Pre 90% Far Site CF update

Mucking drift update

Proximity of monorail to ducting and AHU

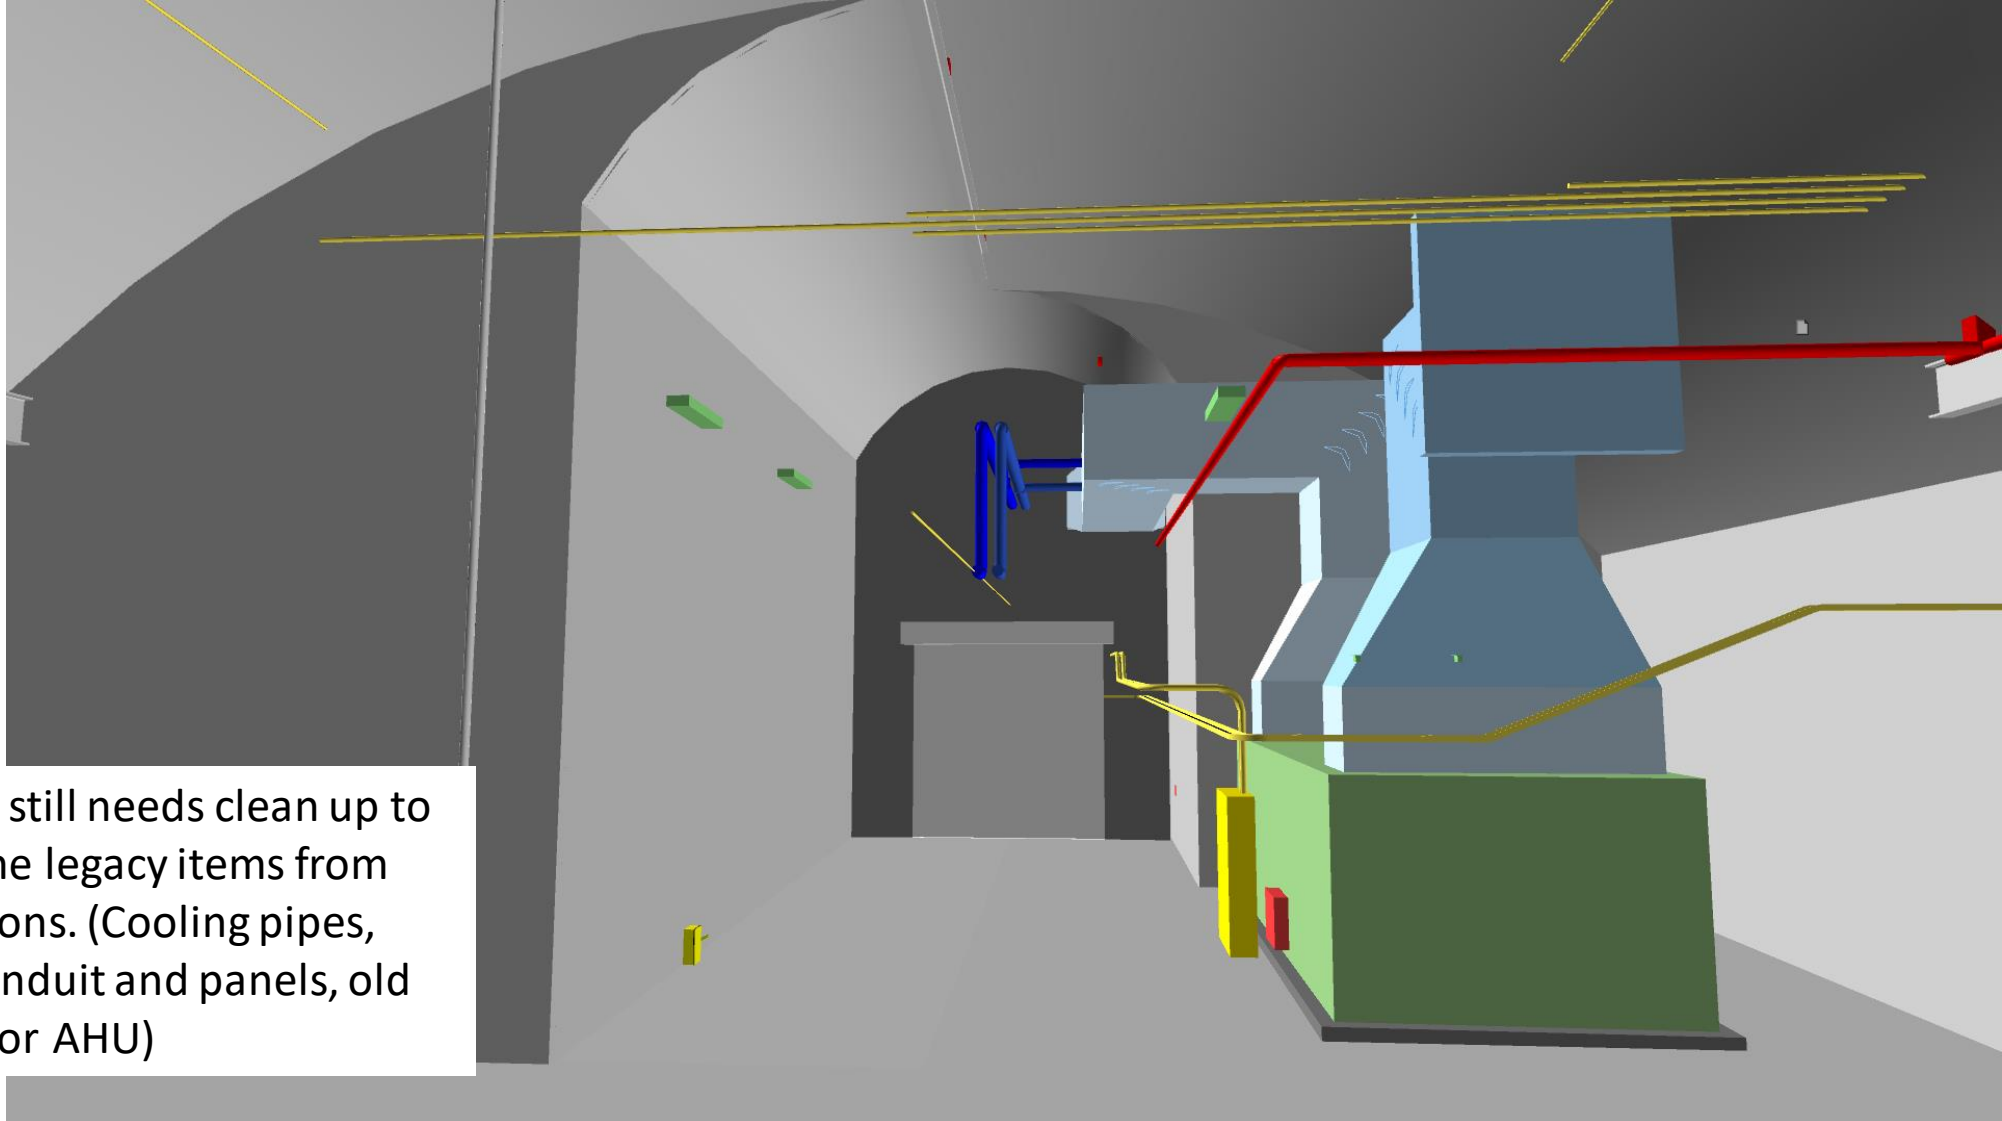
Note model still needs clean up to remove some legacy items from earlier versions. (Cooling pipes, electrical conduit and panels, old mezzanine for AHU)

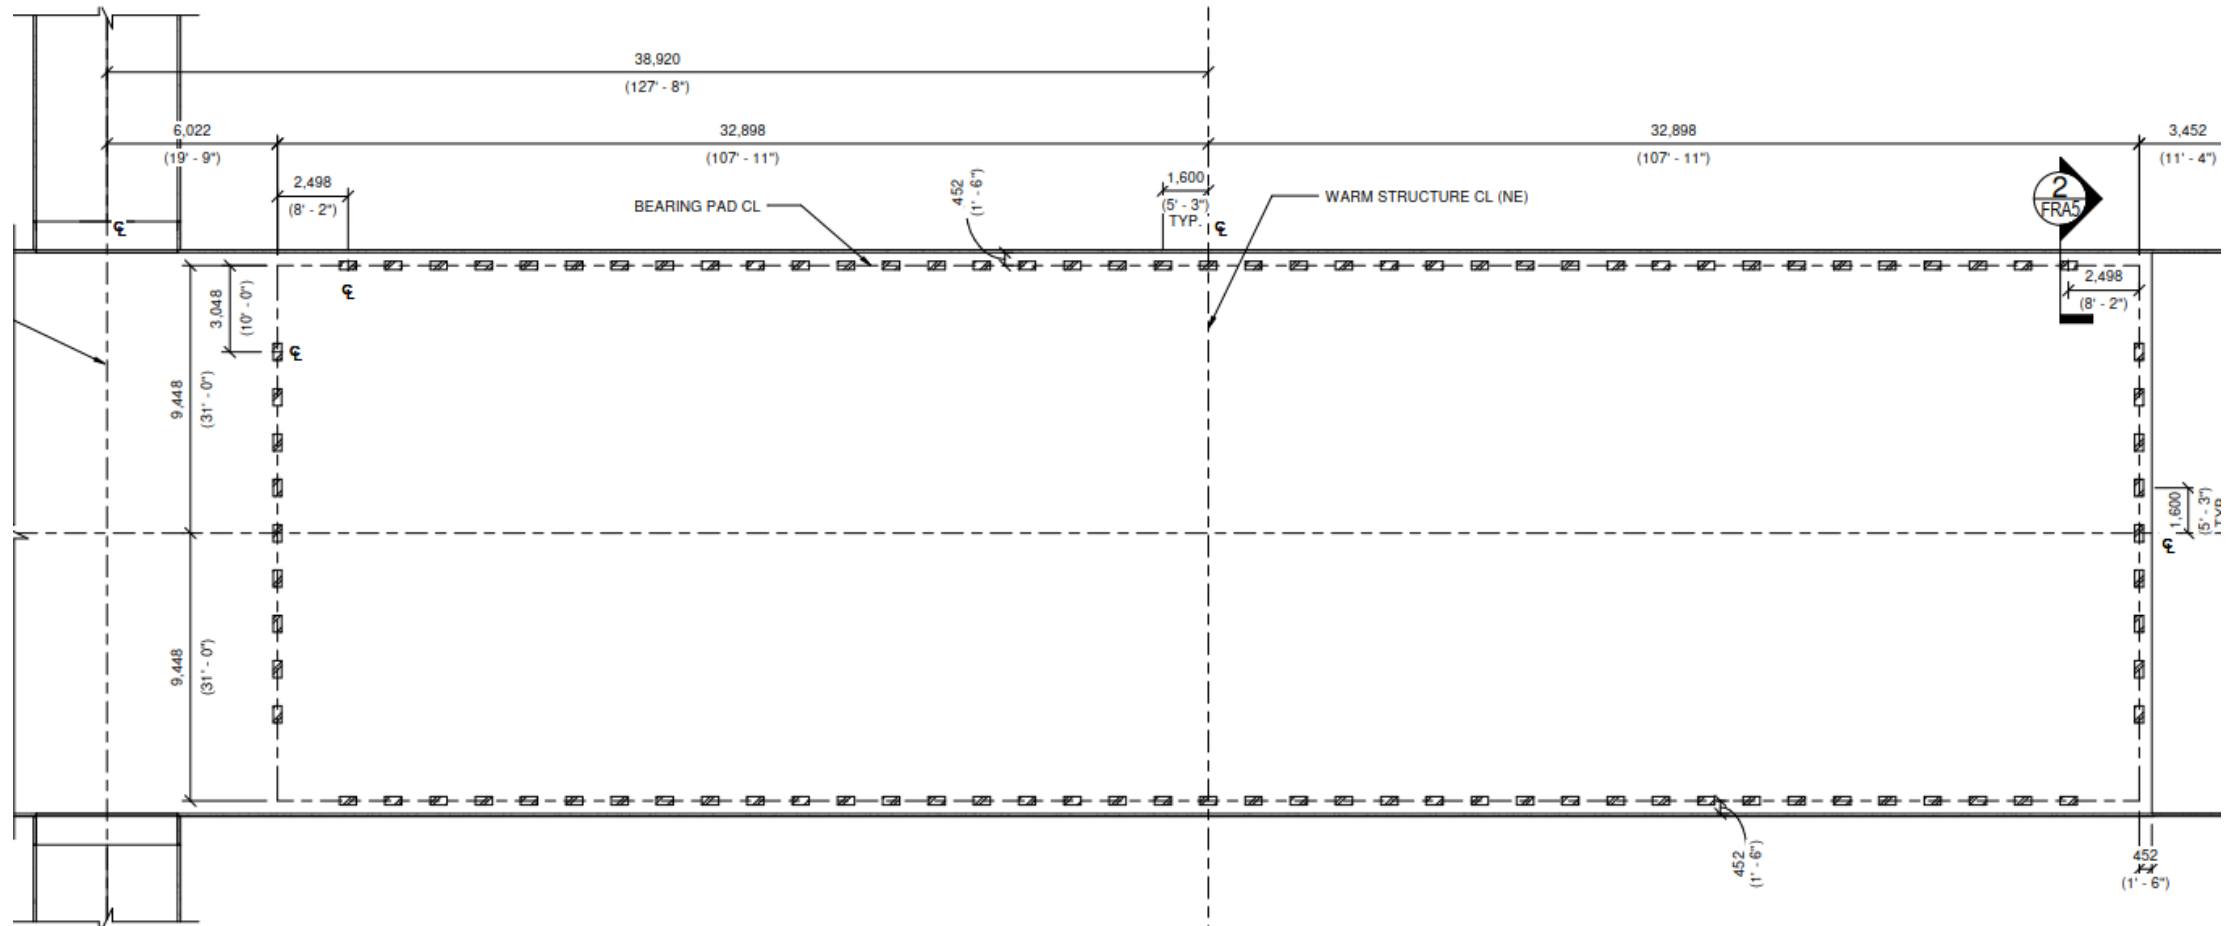
Changes from 60% are being verified

CENTRAL MONORAIL CRANE BEAM SUPPORT

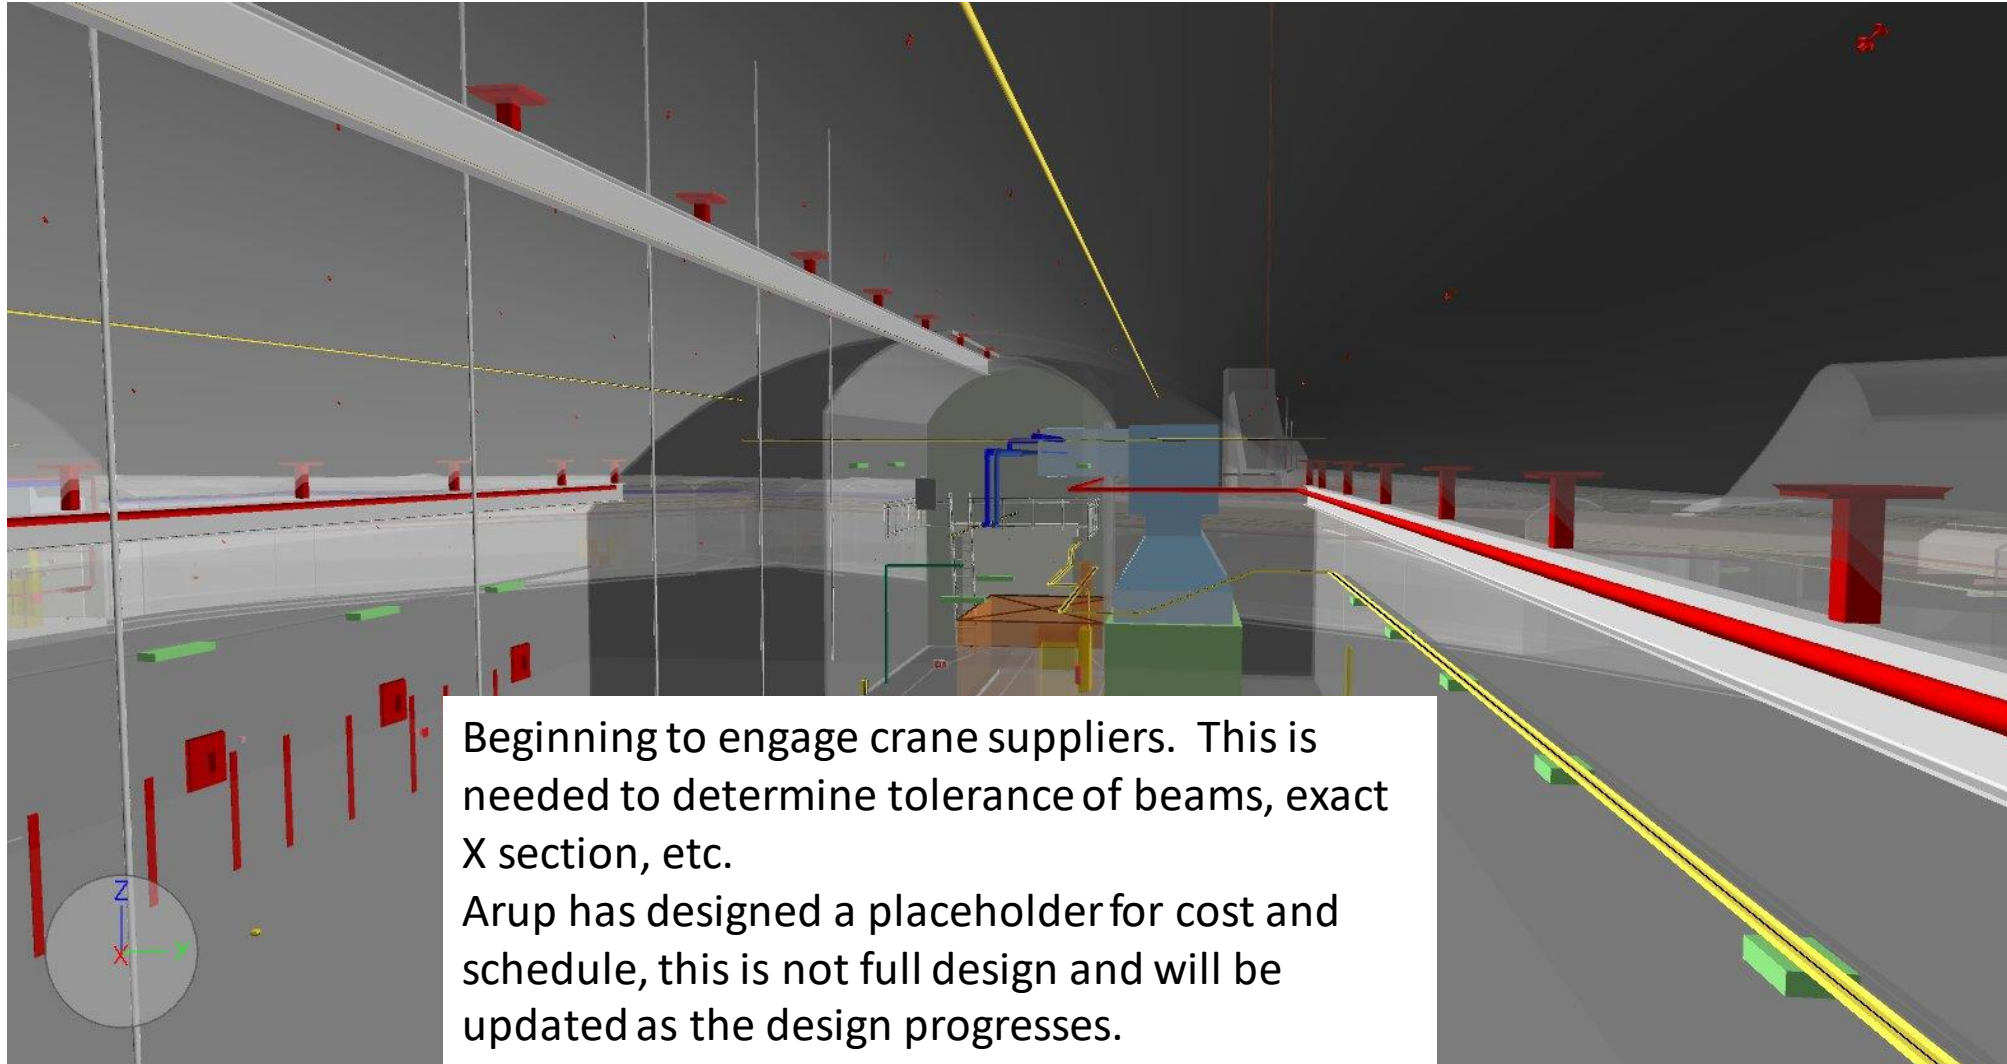
Hangers are implemented, place holder for rails

Beginning to engage crane suppliers. This is needed to determine tolerance of beams, exact X section, etc.

Arup has designed a placeholder for cost and schedule, this is not full design and will be updated as the design progresses.

Monorail placement

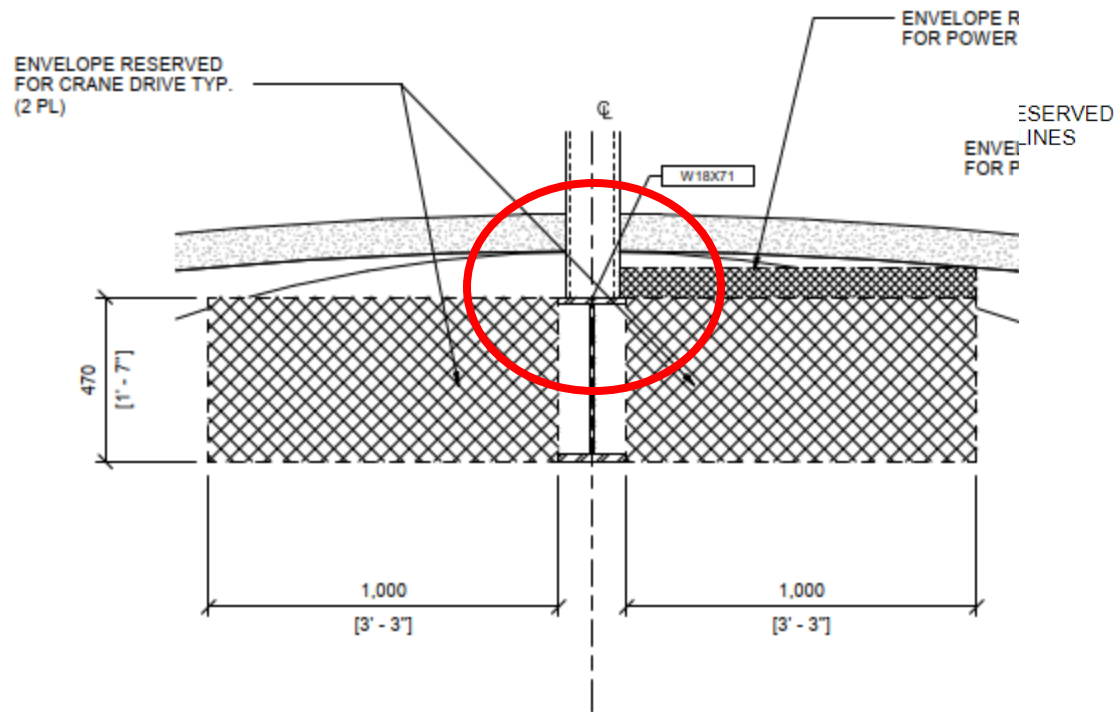
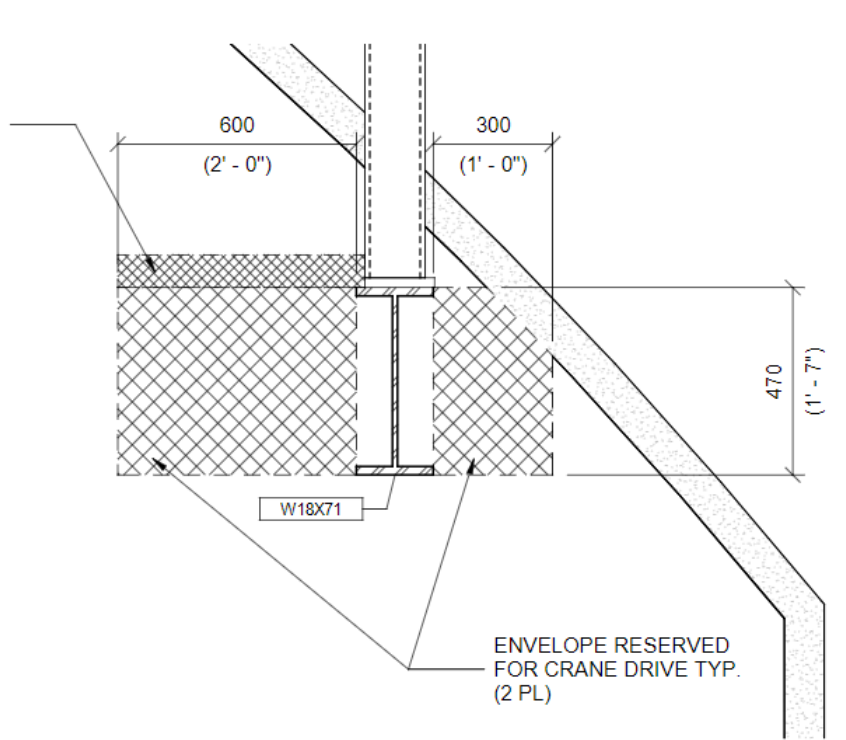
Center monorail will be shifted 100 mm (4 in) to accommodate. ARUP is working through alternate solutions for outer monorails.

Mezzanine supports, verify location

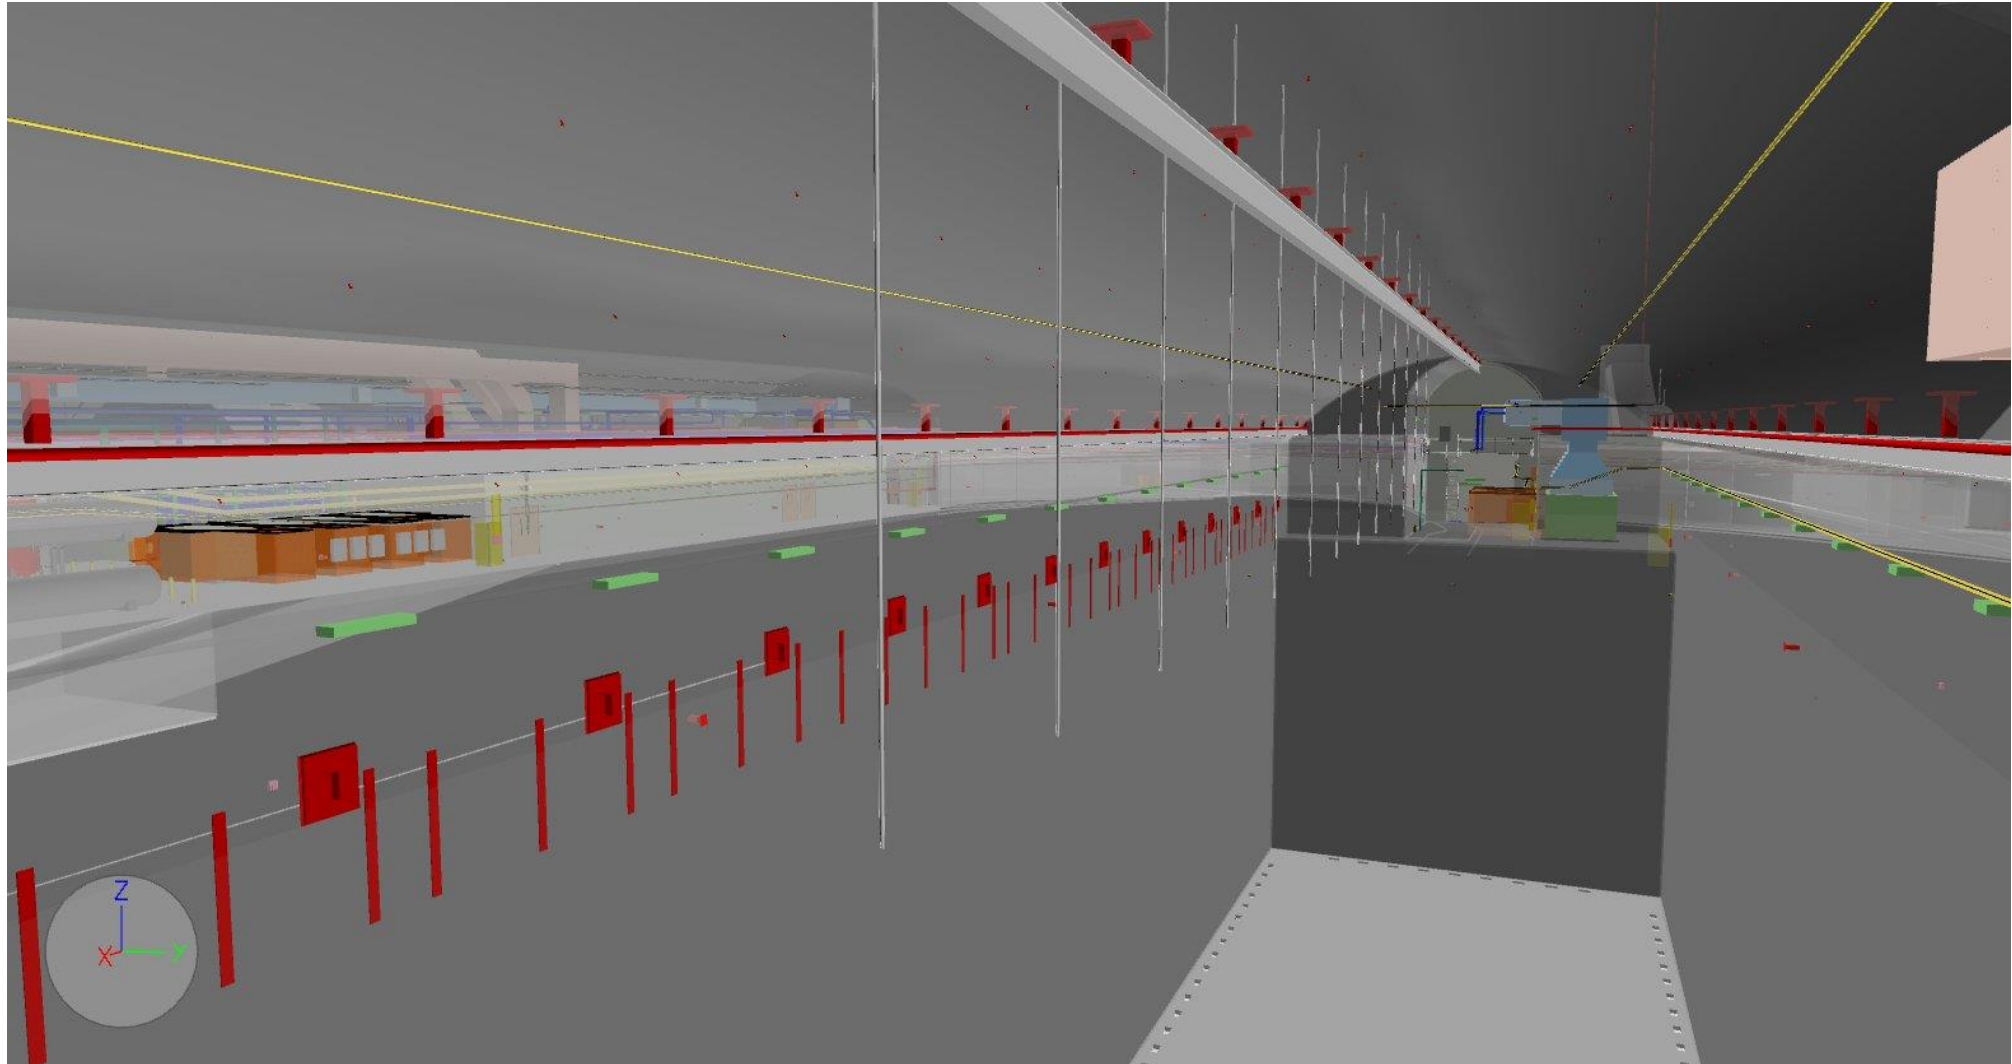
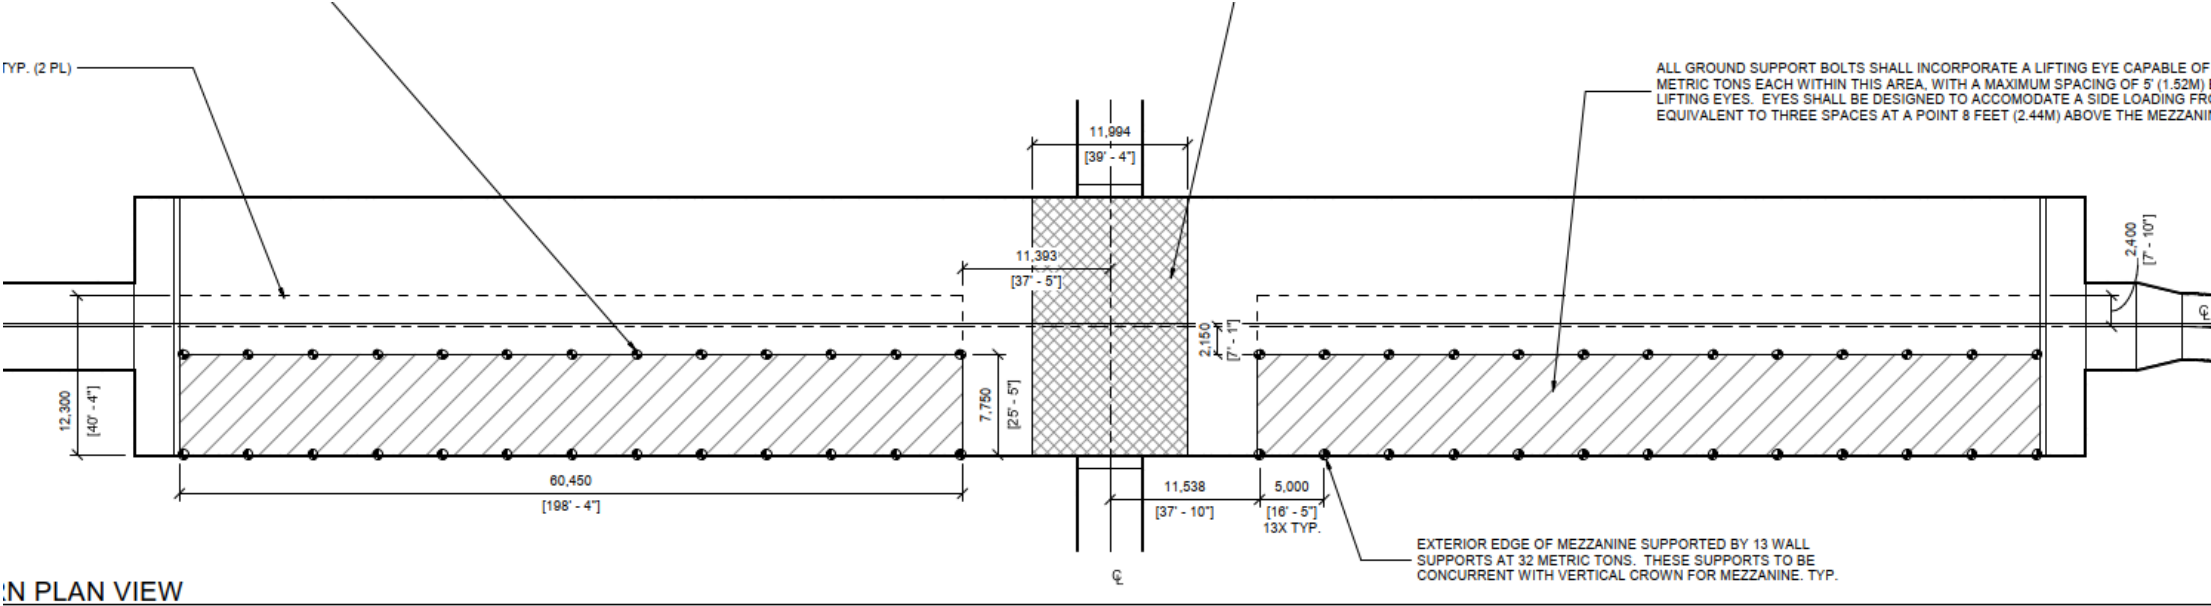
Dimensions below to be confirmed

The Tee brackets will be field welded to the flat plates anchored to the rock. This location of the Tee brackets will be surveyed.
